Work Order ID 111579

Item Name: Floor Provisions

DART SERVICE INSTRUCTION

TO AMEND INSTALLATION INSTRUCTIONS IIN-D350-689 REV. B
AND INSTRUCTIONS FOR CONTINUED AIRWORTHINESS ICA-D350-689 REV. 1

FIGURE 1: UPDATES TO CROSS SECTIONS F-F AND M-M

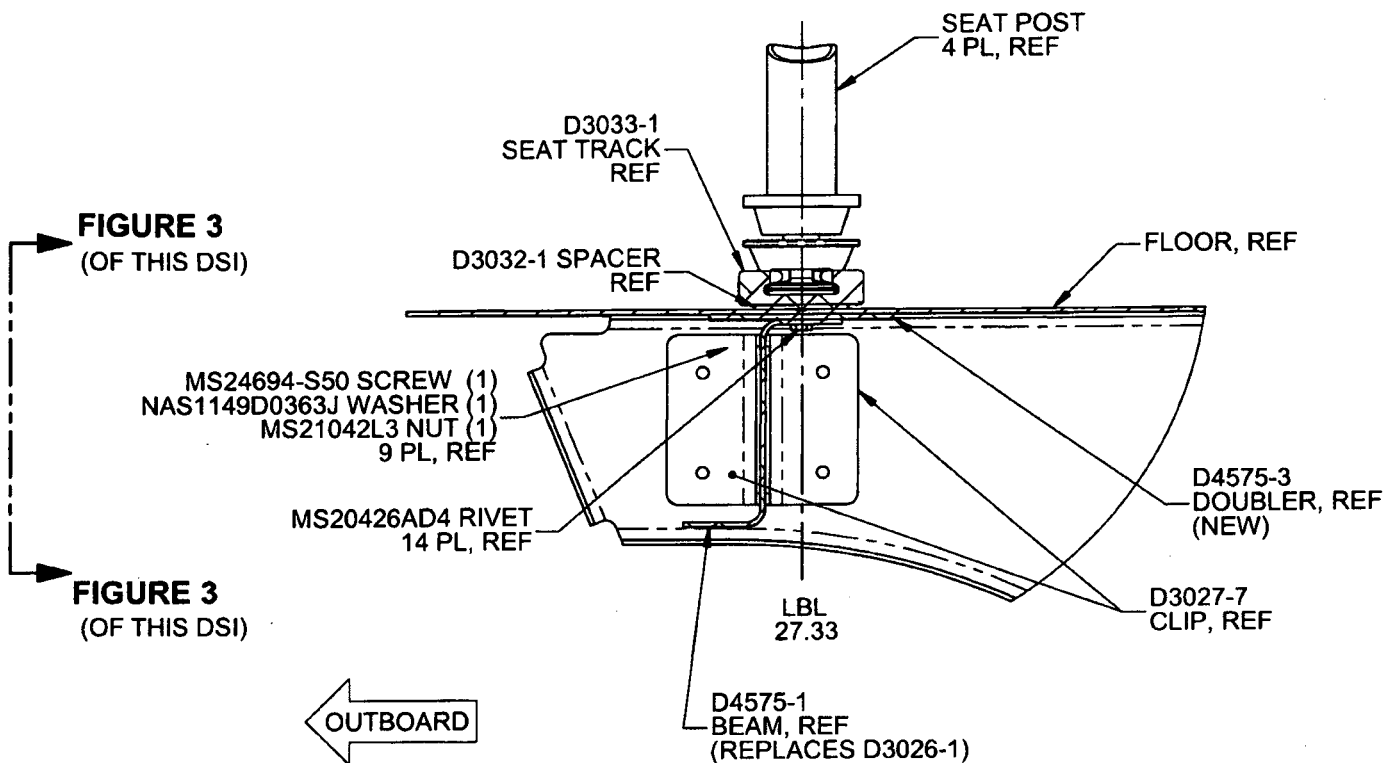
If there is an existing stringer at LBL 27.33, it will need to be removed from that location. Locate D4575-1 Beam, D4575-3 Doubler, and D3032-1 Spacer as shown in Figure 1 of this Service Instruction. Transfer drill existing holes from the aircraft floor to the D4575-1 Beam, D4575-3 Doubler, and D3032-1 Spacer. Ensure 1.0" to 1.5" rivet pitch and add additional holes if required. If there is no existing stringer, locate D4575-1 Beam, D4575-3 Doubler, and D3032-1 Spacer as shown in Figure 1 of this Service Instruction and drill Ø0.128" holes on a 1.0" to 1.5" pitch.

Counter sink holes in the D3032-1 Spacer for MS20426AD4 rivets. Install D4575-1 Beam, D4575-3 Doubler, and D3032-1 Spacer to floor using MS20426AD4 rivets.

CROSS SECTION VIEW F-F/M-M: From Figures 5 and 7 (IIN-D350-689)
CROSS SECTION VIEW F-F/M-M: From Figures 25-5 and 25-7 (ICA-D350-689)

With reference to Figures 5 and 7 of IIN-D350-689
 (Figures 25-5 and 25-7 of ICA-D350-689)

FIGURE 2: UPDATES TO FIGURE 21 (IIN-D350-689) AND 25-21 (ICA-D350-689)

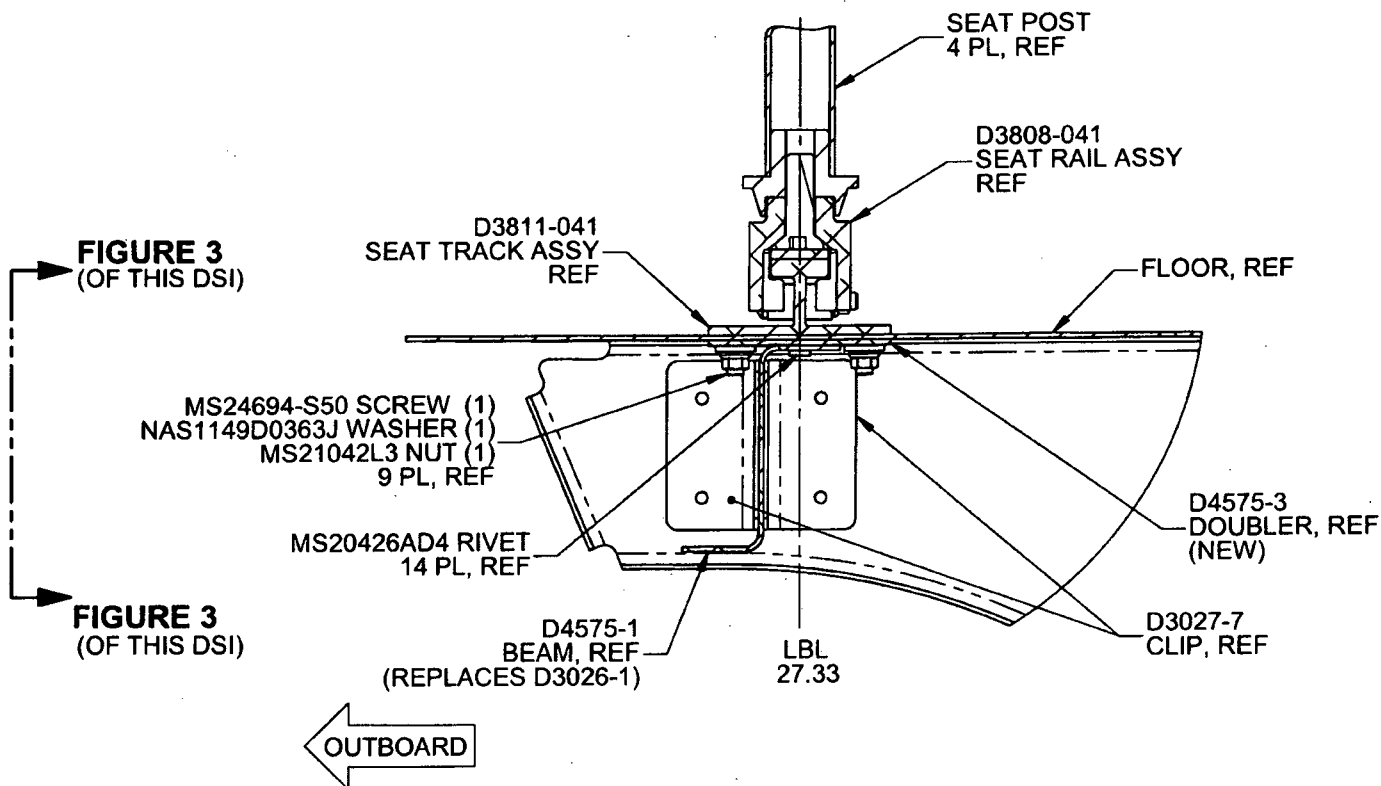
If there is an existing stringer at LBL 27.33, it will need to be removed from that location. Locate D4575-1 Beam and D4575-3 Doubler as shown in Figure 2 of this Service Instruction. Transfer drill existing holes from the aircraft floor to the D4575-1 Beam and D4575-3 Doubler. Ensure 1.0" to 1.5" rivet pitch and add additional holes if required. If there is no existing stringer, locate D4575-1 Beam and D4575-3 Doubler as shown in Figure 1 of this Service Instruction and drill Ø0.128" holes on a 1.0" to 1.5" pitch.

FIGURE 21: Cross Section View T-T from Figure 19 (IIN-D350-689)
FIGURE 25-21: Cross Section View T-T from Figure 25-19 (ICA-D350-689)

With reference to Figures 19 and 20 of IIN-D350-689
 (Figures 25-19 and 25-20 of ICA-D350-689)

FIGURE 3: RELIEFS ON D4575-1/-3
(ONLY D4575-1/-3 SHOWN FOR CLARITY)
VIEW LOOKING INBOARD

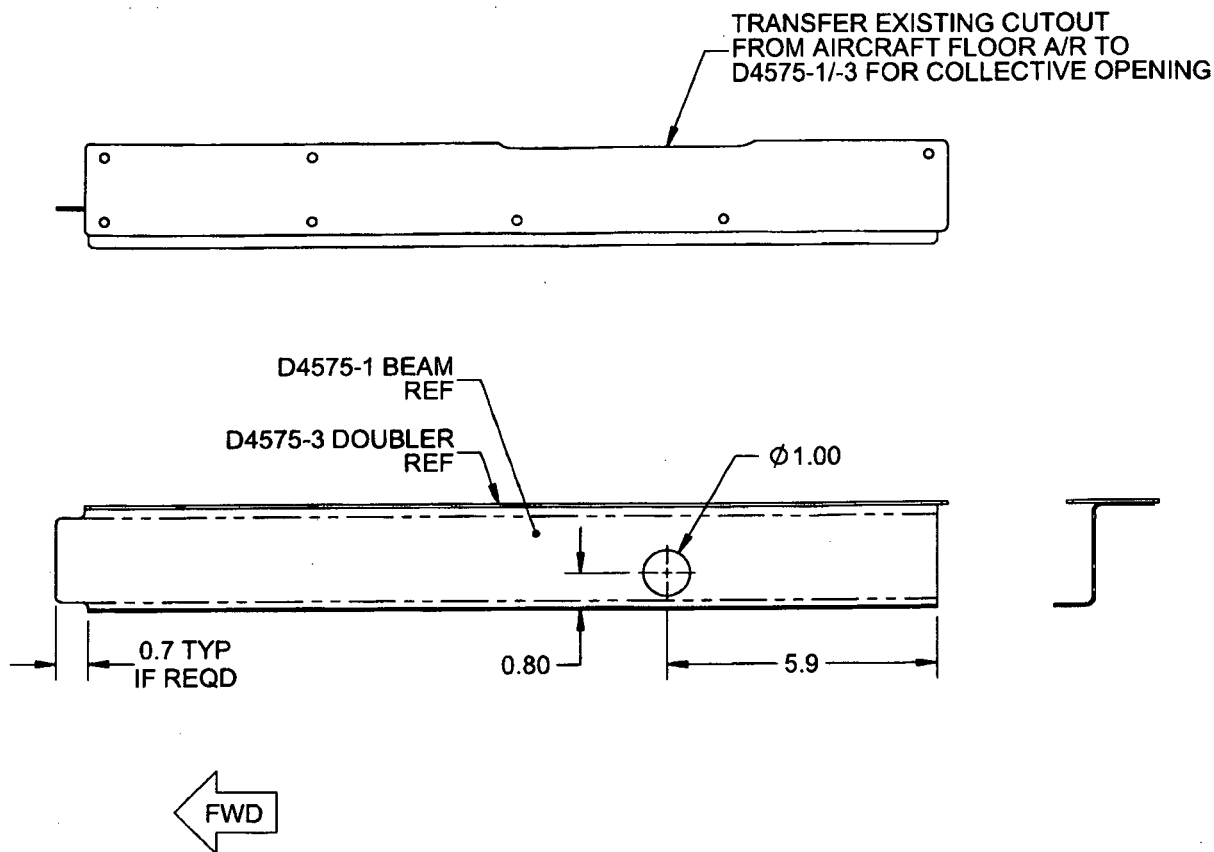
Note: Drill a Ø1.00" (Ø25.4 mm) hole in the D4575-1 Beam to clear extension tube of collective and cutout as required for clearance of collective opening and fwd bulkhead as shown in Figure 3 of this Service Instruction.

Note: Drill a Ø1.00" (Ø25.4 mm) hole in the D4575-1 Beam to clear extension tube of collective and cutout as required for clearance of collective opening and fwd bulkhead as shown in Figure 3 of this Service Instruction.
